ADDENDUM No. 1

REQUEST FOR QUOTATIONS No.: 1220-040-2022-020

TITLE: Coverdale Fairgrounds Shannon Hall Boiler Replacement

ADDENDUM ISSUE DATE: February 15, 2022

CONSULTANT:

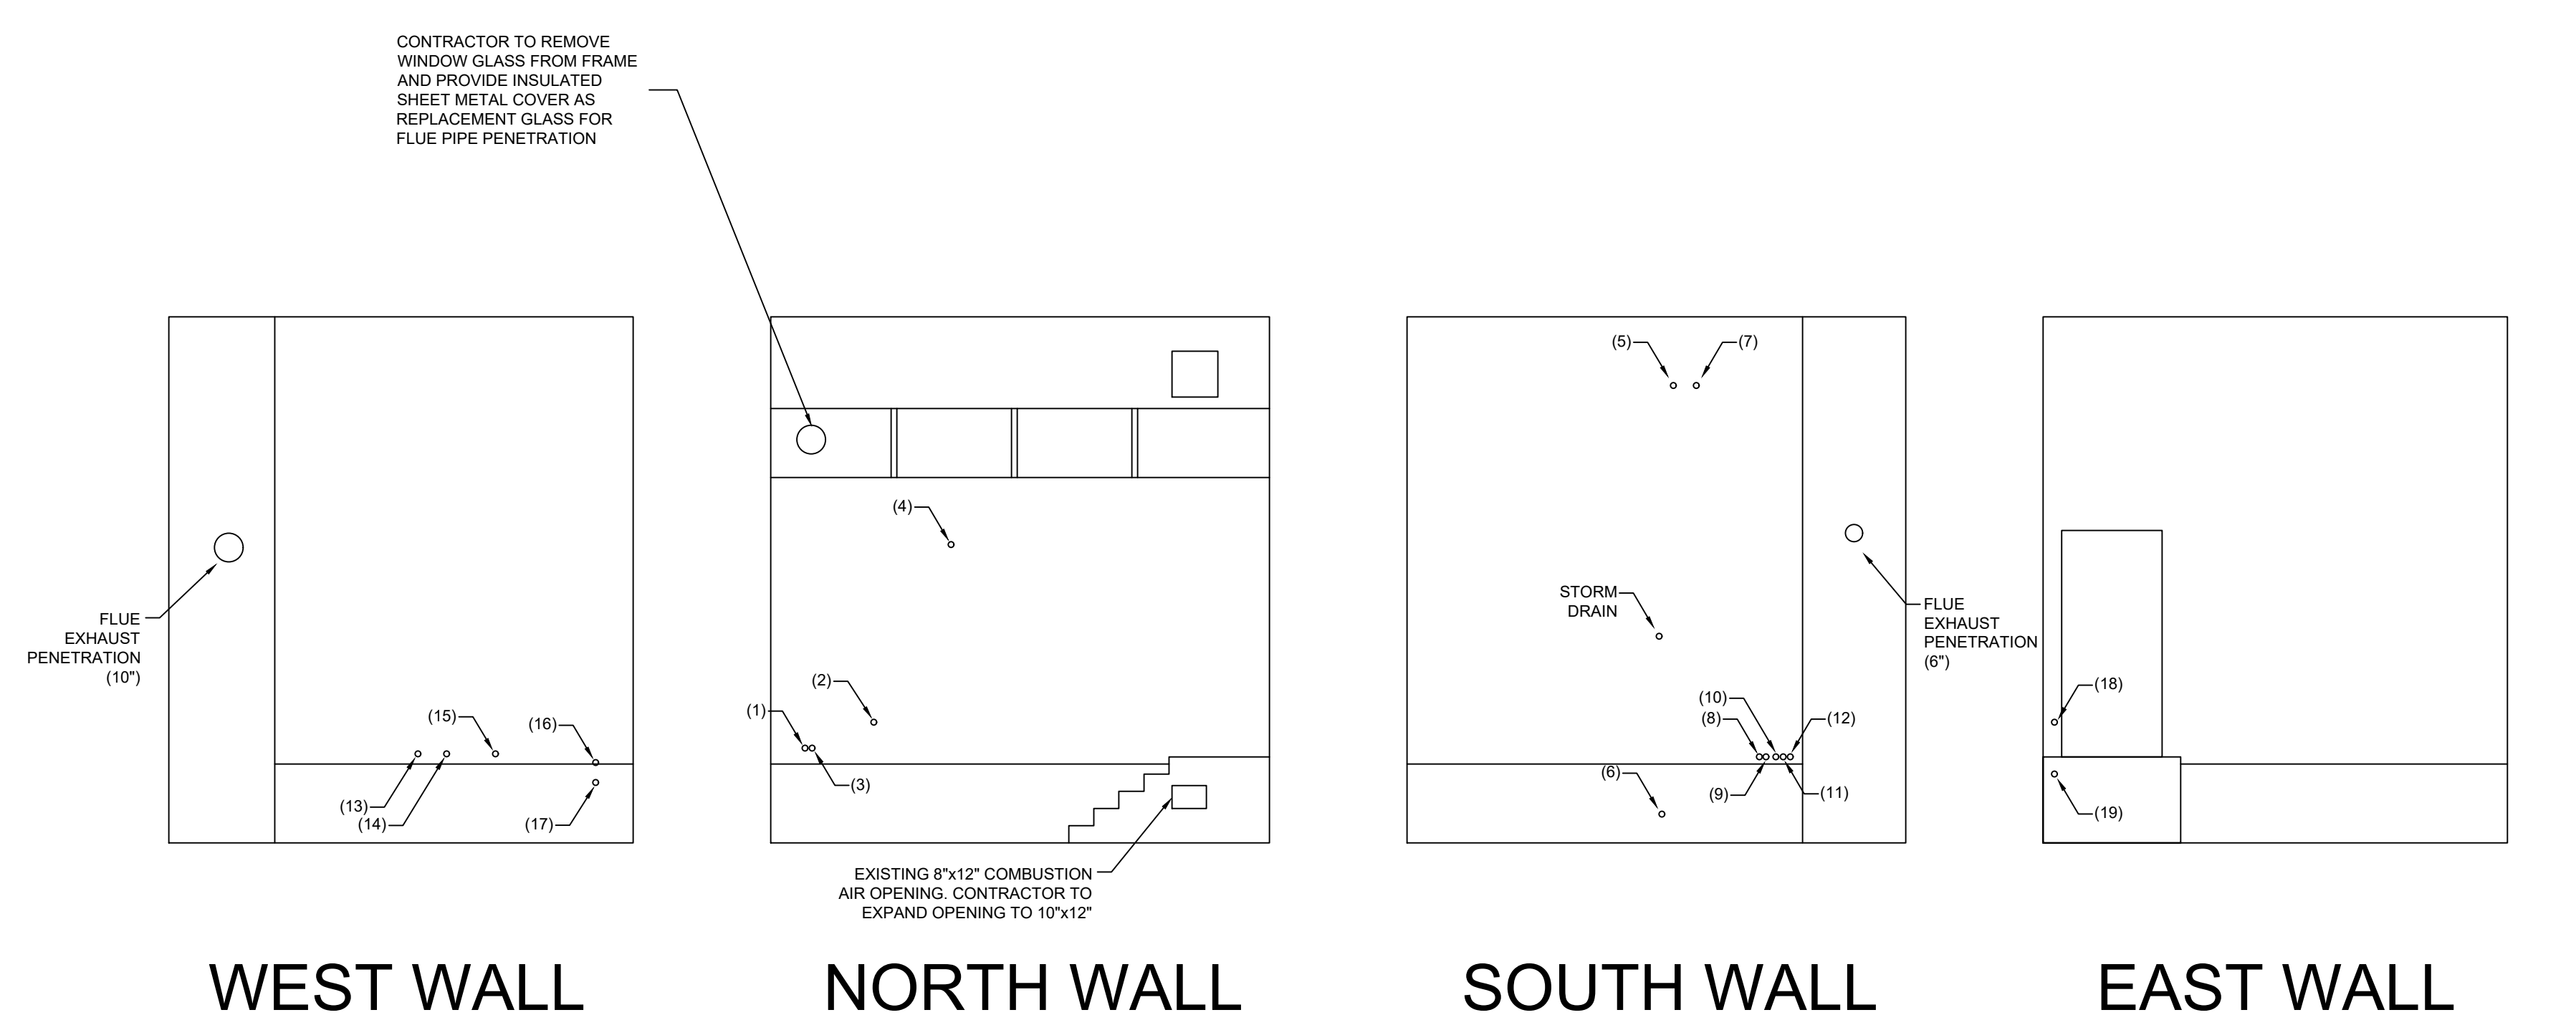
Q7. To avoid dealing with abatement on the proposed lead paint on the walls. Can we terminate the flue through a crafted box to match the exterior walls?

A7. Thank you for the proposed solution, however the flue pipe termination is noted on detail #3 of drawing M1.02 [Mechanical Room Wall Piping Penetrations] as terminating through the window, which to our understanding does not require any abatement.

1 CASCADING OPERATION VALVE POSITIONS
M1.03 SCALE: NTS

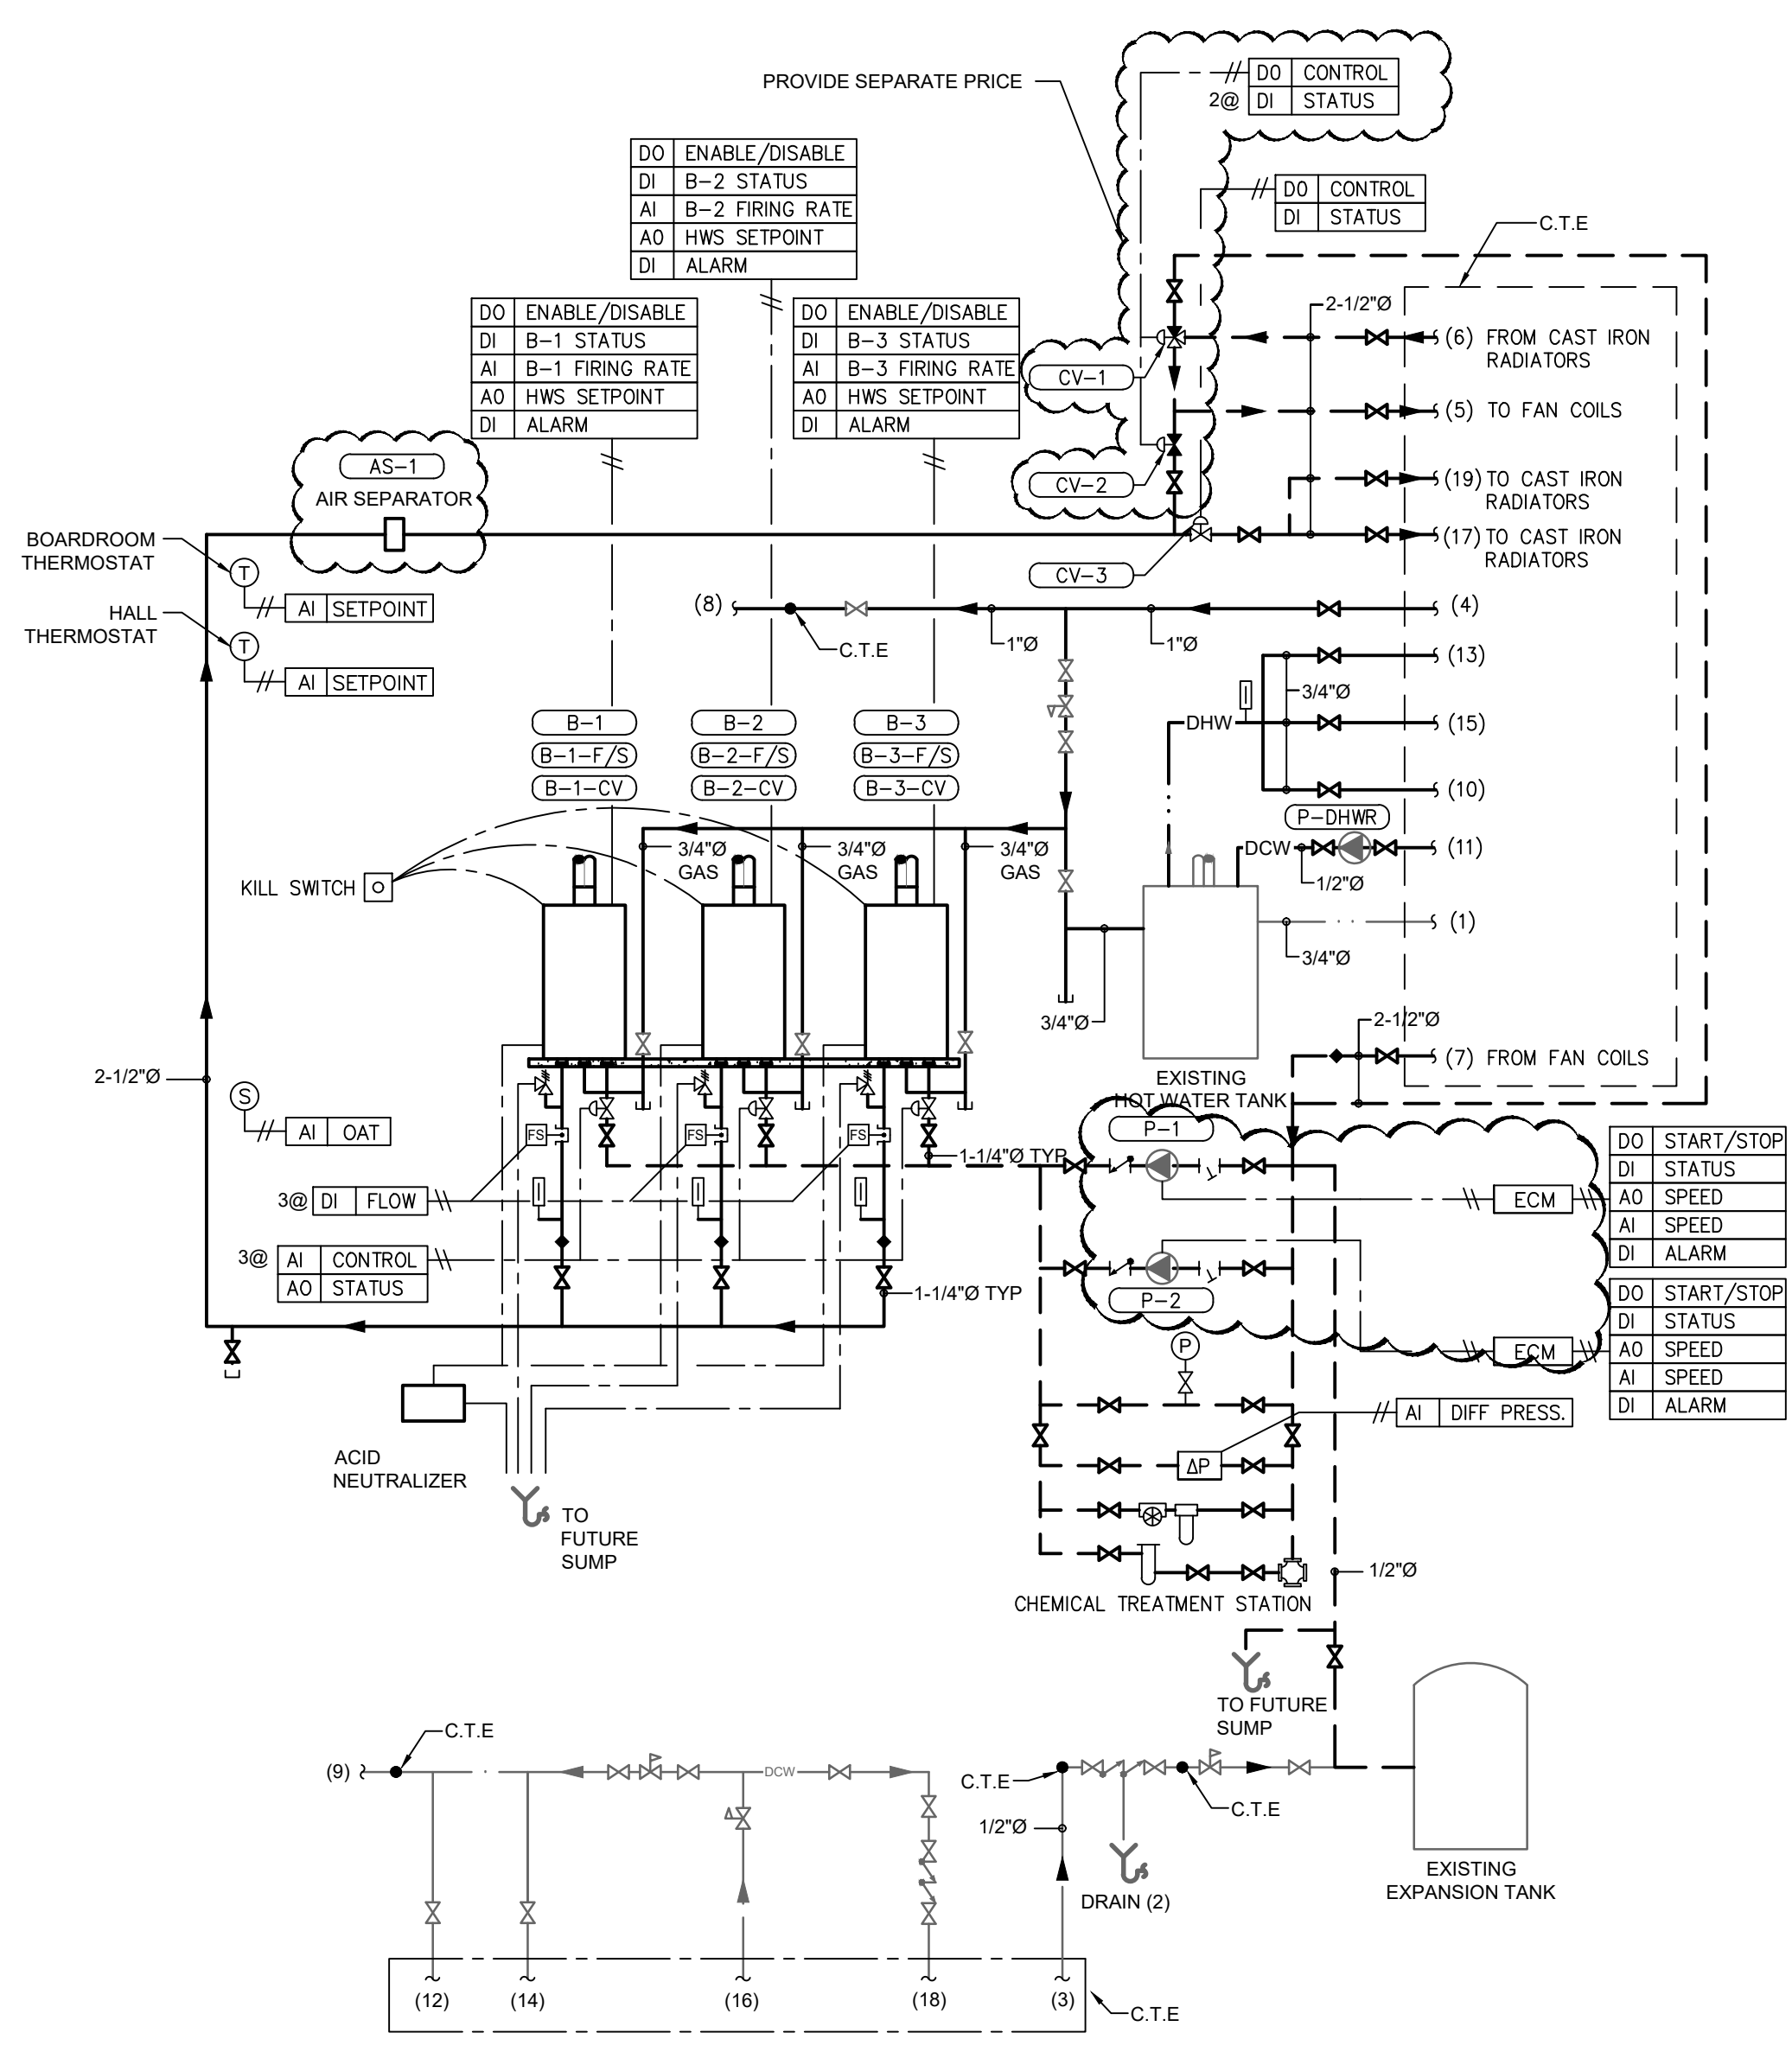
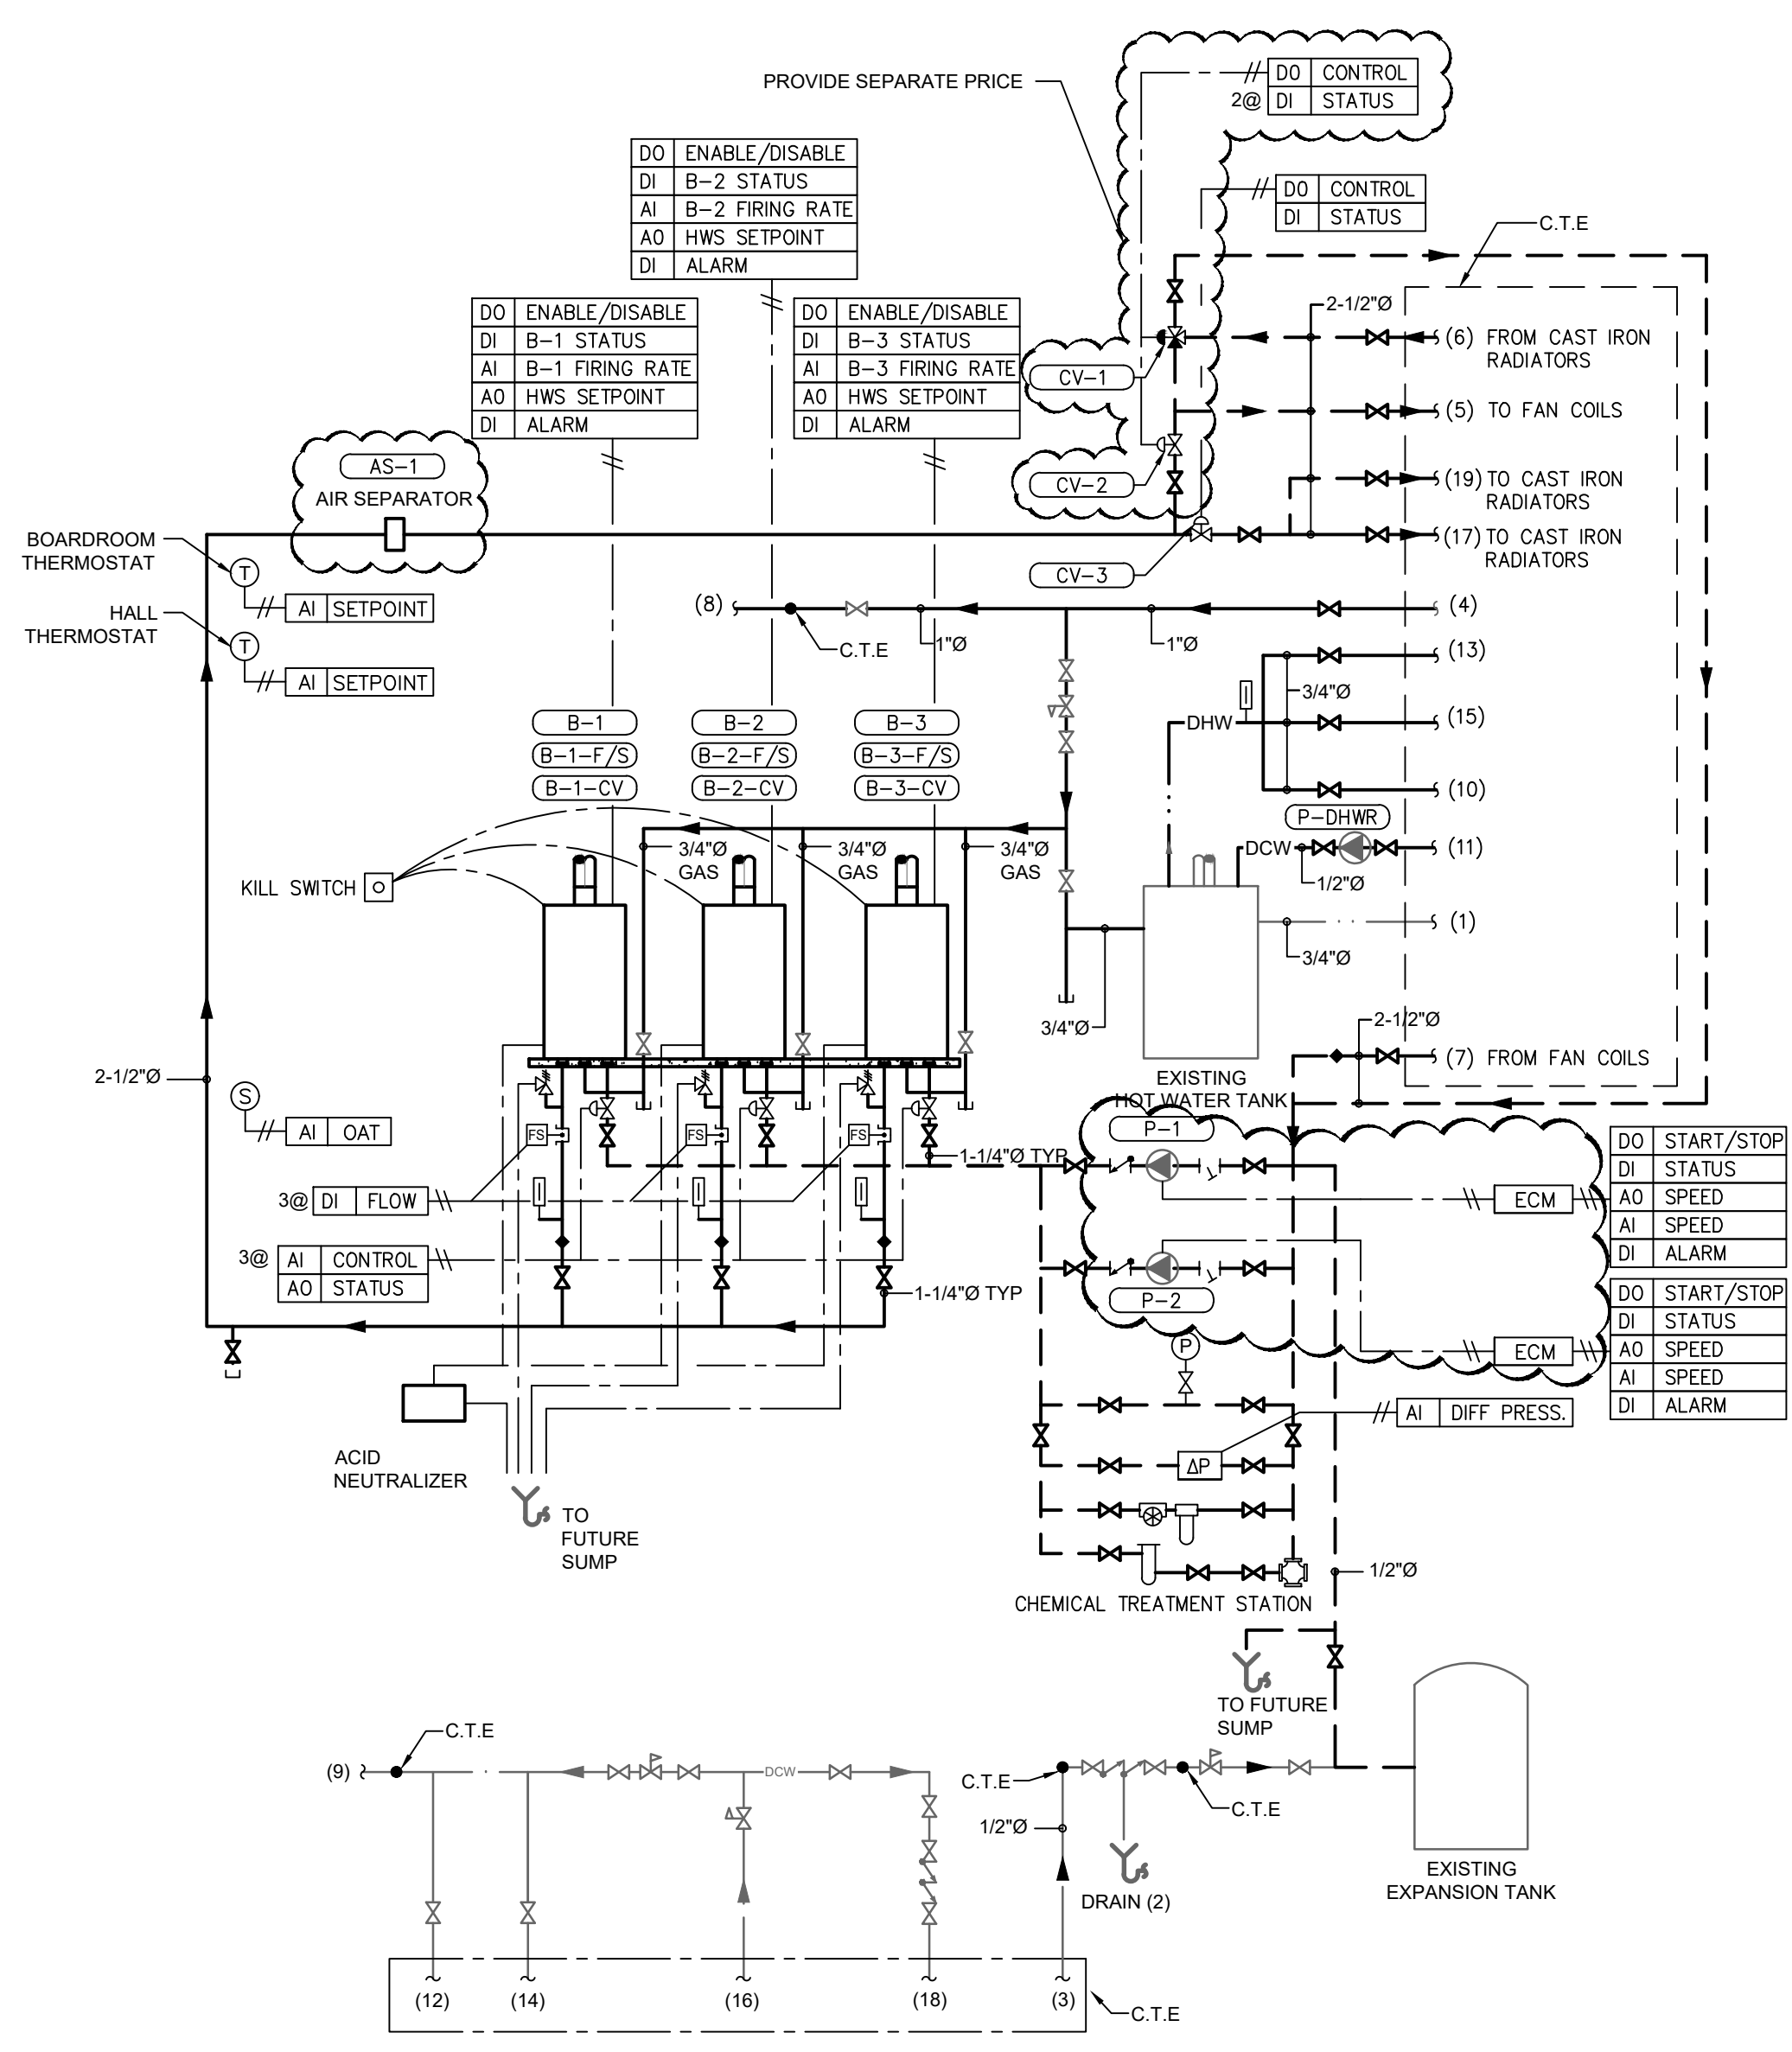
1.3 Drawing No.: M1.03 – Cascading Operation Schematics

- .1 Add:
 - .1 Tag AS-1 for Air Separator added to 2/M1.01
- .2 Delete:
 - .1 Note: “Existing Pumps” on P-1,2 deleted from 1/M1.03 and 2/M1.03.
 - .2 Tags V-1,2 on VSD deleted from 1/M1.03 and 2/M1.03
- .3 Revise:
 - .1 “VSD” on circulation pumps P-1,2 changed to “ECM”
